ADDENDUM NO. 1 - OUTLINE AND SUMMARY INFORMATION

Project Name: Reid Hall – Center for Research on Rural Education Renovation

Date: March 24, 2026 **Addendum #:** 1
Project: MSU Reid Hall Center for Research on Rural Education
Project #: 25032
To: All Plan Holders of Record

6" PERFORATED DISCHARGE PIPE

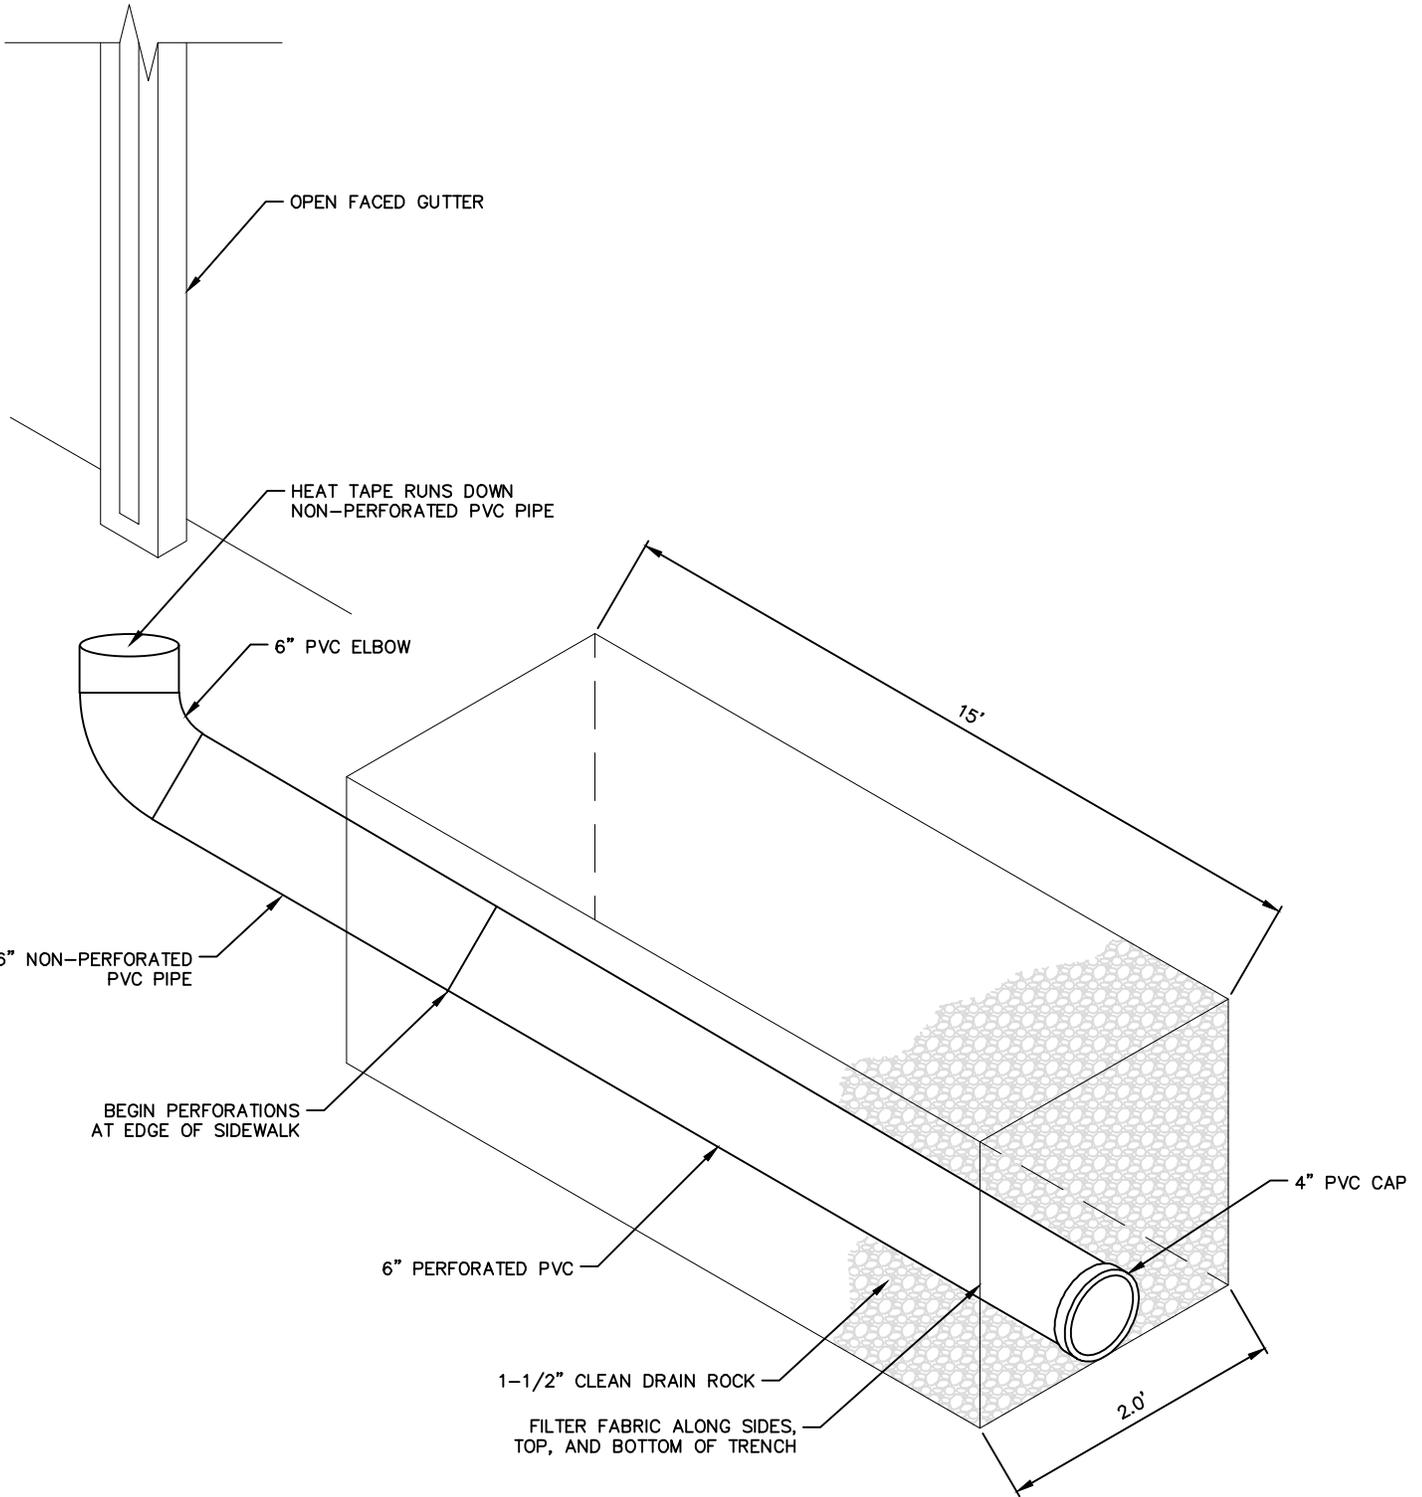
- 1) 6" PERFORATED DISCHARGE PIPE DETAIL - Attached
- 2) PRE-BID SIGN-IN SHEET - Attached

Q2. Pipe size should be 6" and the slope will be field verified based on top of existing tunnel. See detail provided by RPA.
